FIRST DRAFT MINUTES

December 18, 2014 Standards Committee Meeting

RE: Minutes from the December 18, 2014 Standards Committee Meeting

PROPOSED NEW 808-DLIM-01 PARALLEL & TAPERED ACCELERATION LANES (DRAFT)

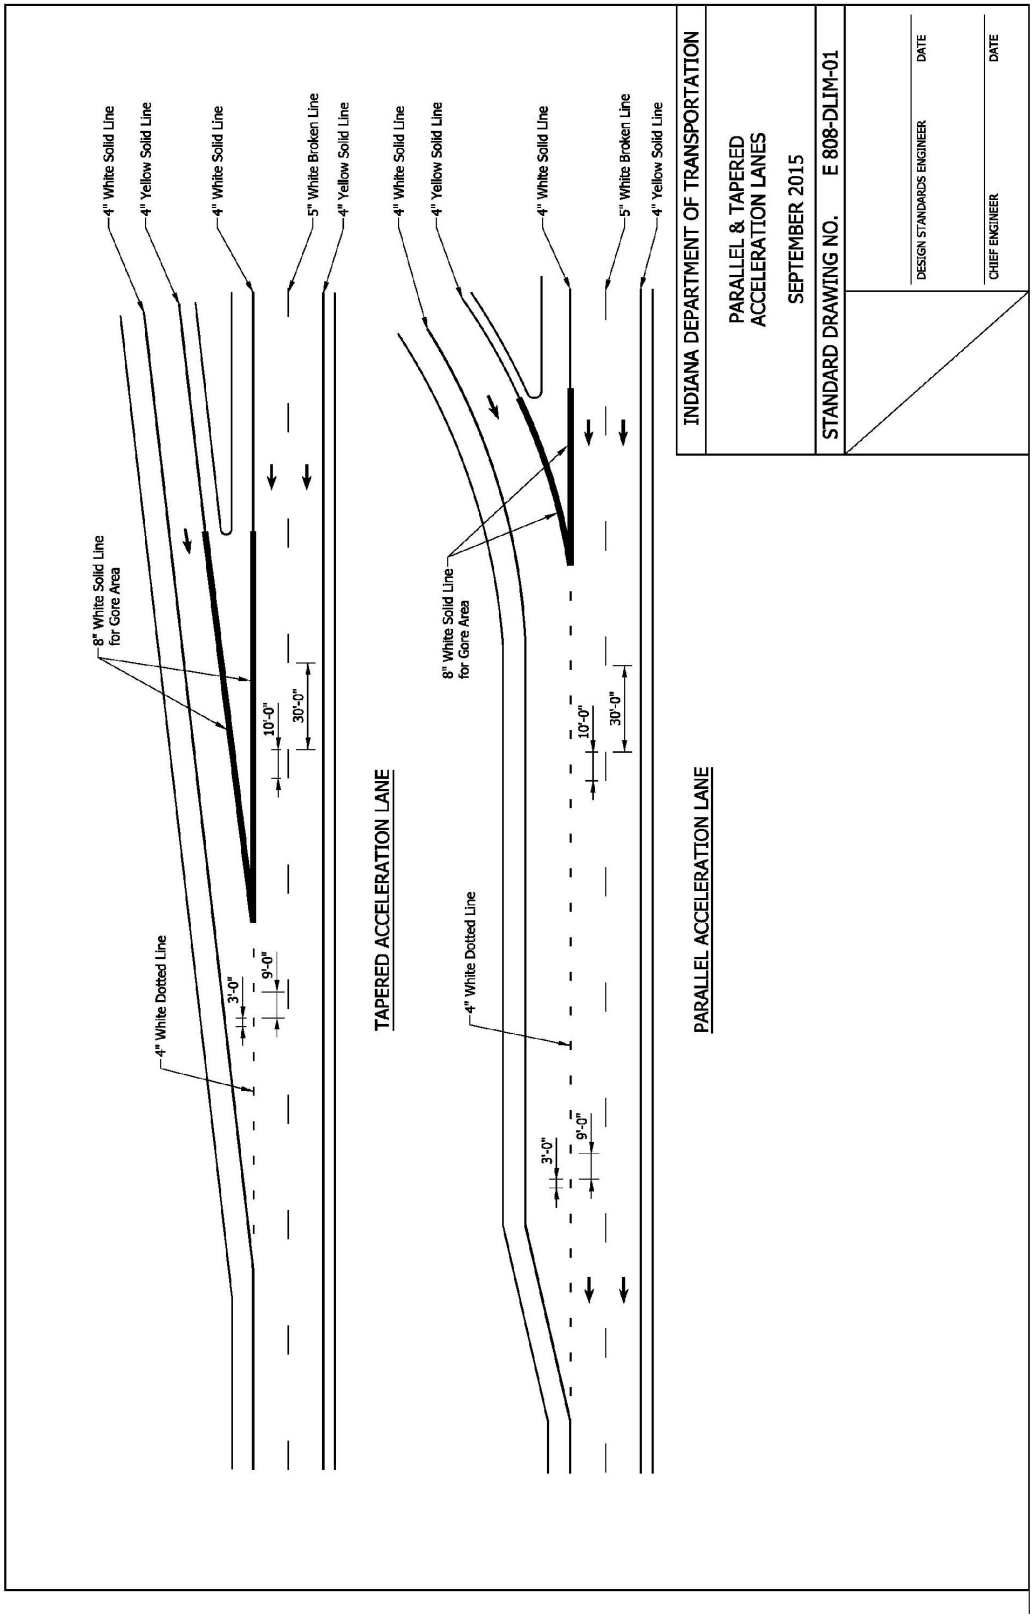
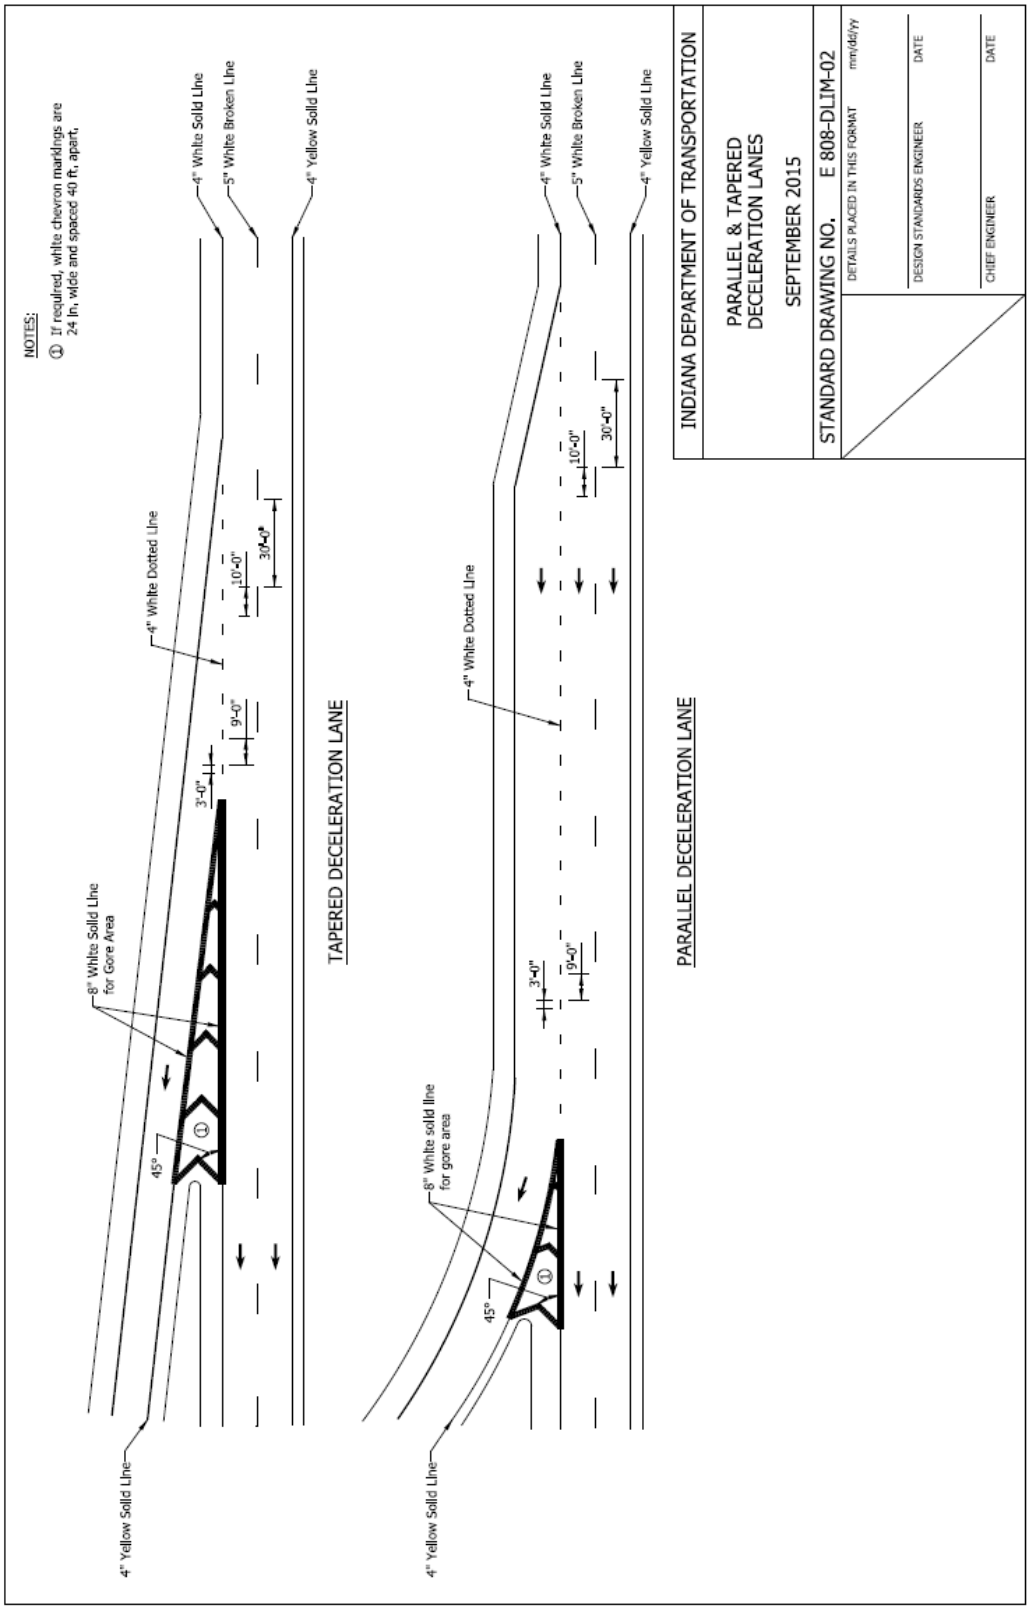
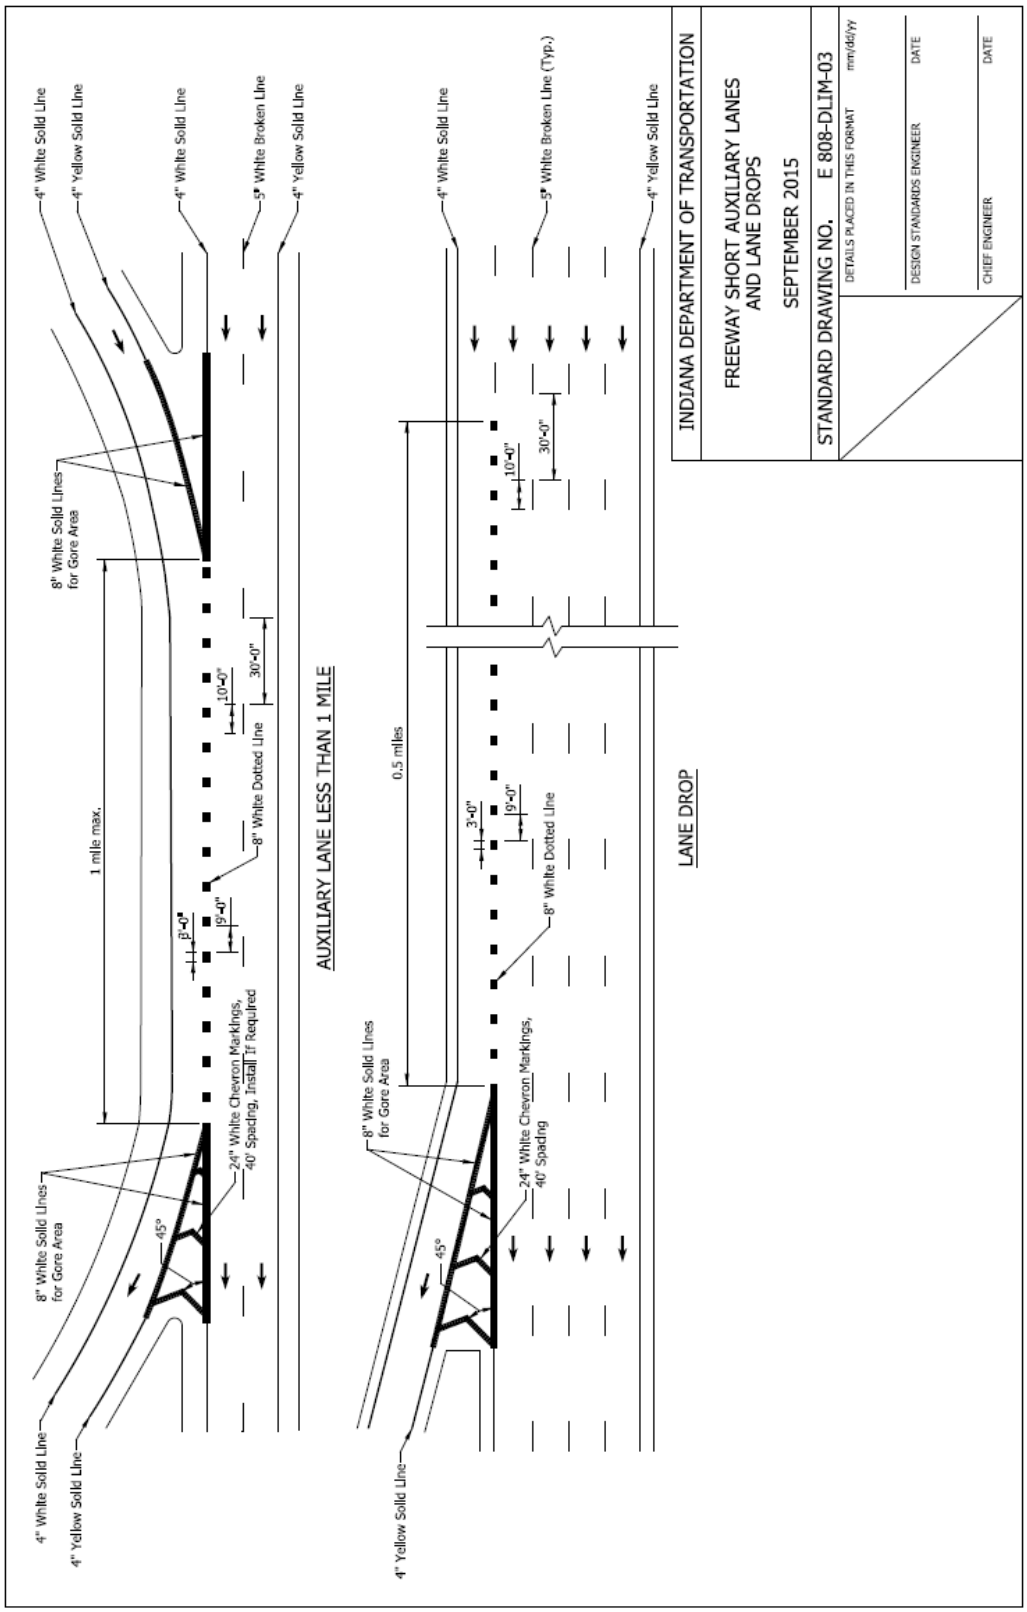
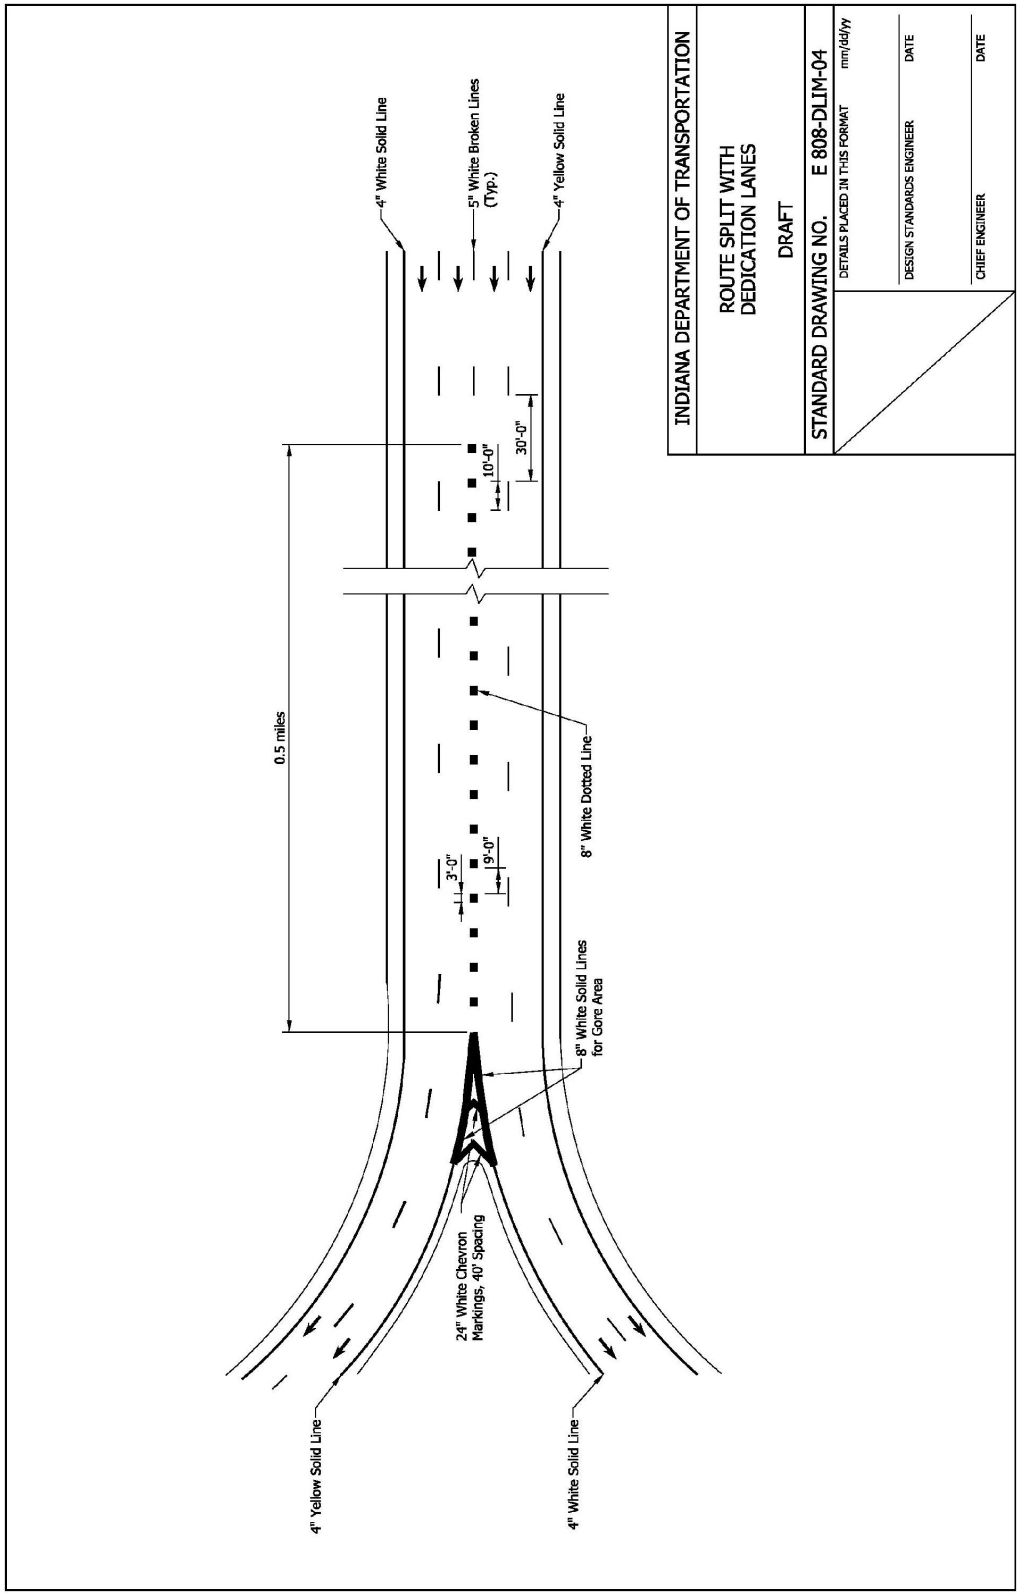
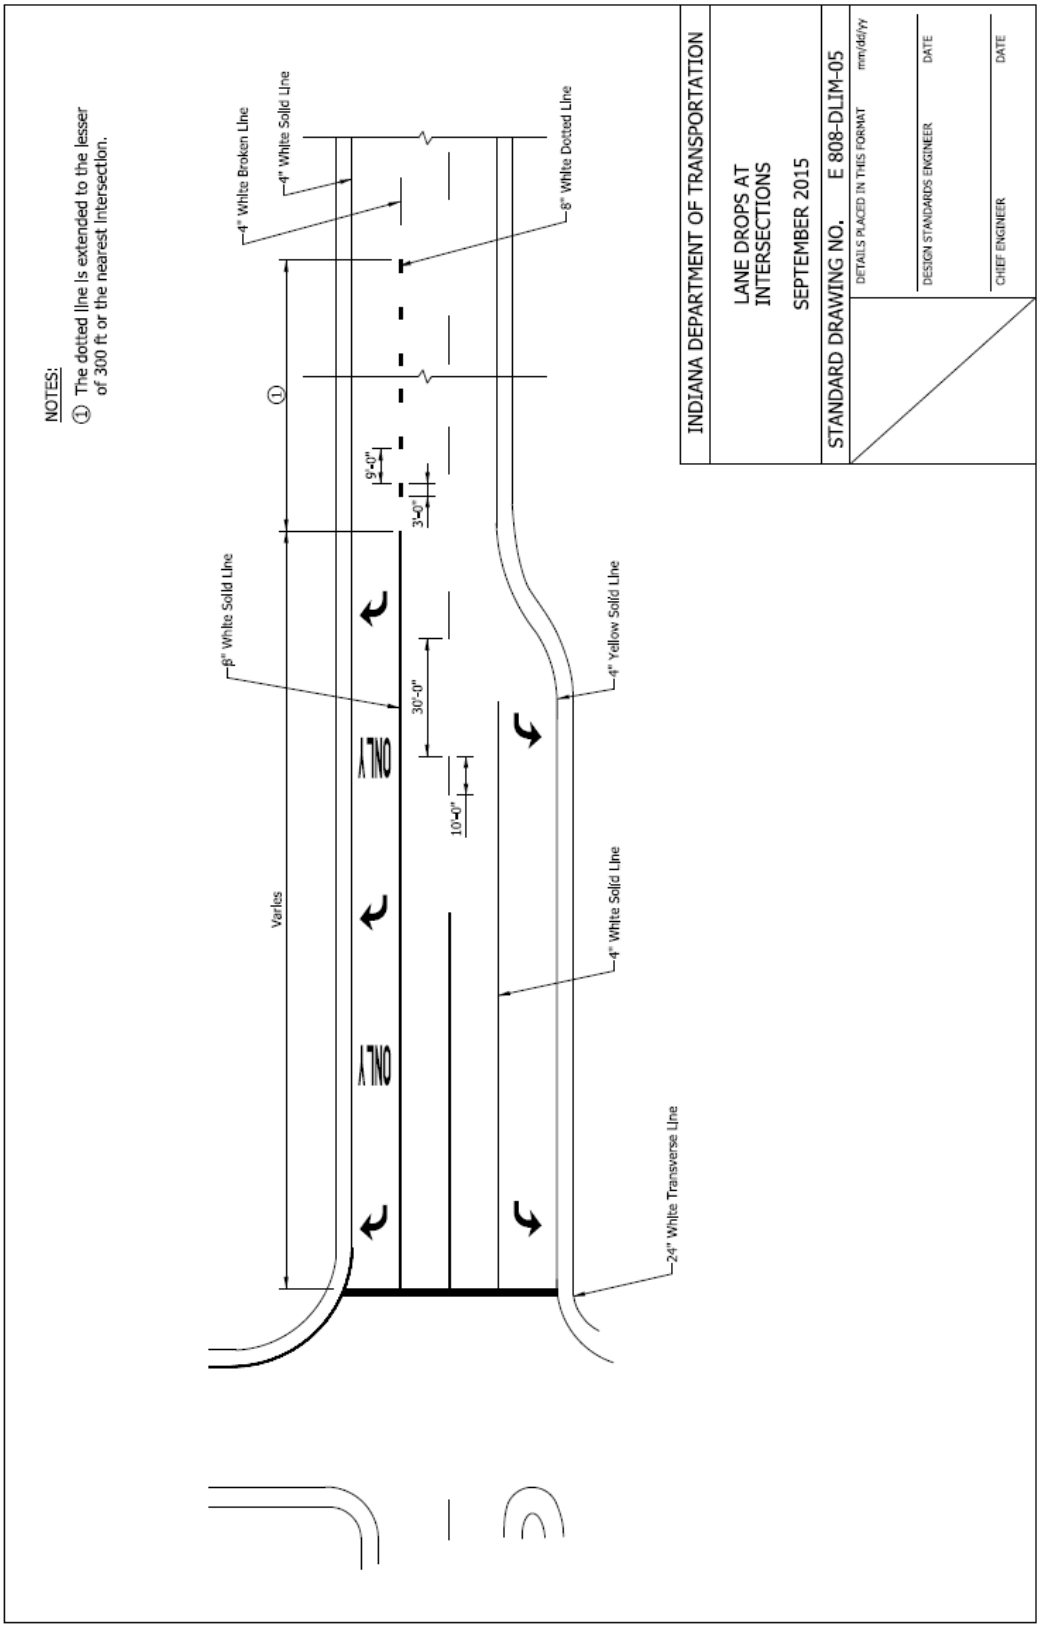
PROPOSED SOLUTION: Create 5 new standard drawings for dotted line interchange/intersection markings (DLIM) and revise the RPM spacing shown in the acceleration lane of Standard Drawing 808-MKRM-08.

DISCUSSION:
Mr. Bruno introduced and presented this item explaining the need to incorporate language pertaining to dotted lane lines into the Standard Specifications and Standard Drawings as required by the MUTCD. Mr. Bruno explained the revisions to drawings as shown. Mr. Bruno handed out additional revisions to some drawings as a result of industry input. Approved revisions shown as *revised draft* in these minutes.
Ms. Phillips asked about the chevrons shown, and Mr. Bruno said that they are optional and up to the designer. Ms. Phillips expressed that if it is shown on the standard drawing then it is assumed to be required. Should there be a note on the drawings stating that they are optional?
Ms. Phillips also asked about lane lines with regard to the gore markings and lane widths. Mr. Cales and Mr. Bruno explained that they fall under barrier lines in 808.04.
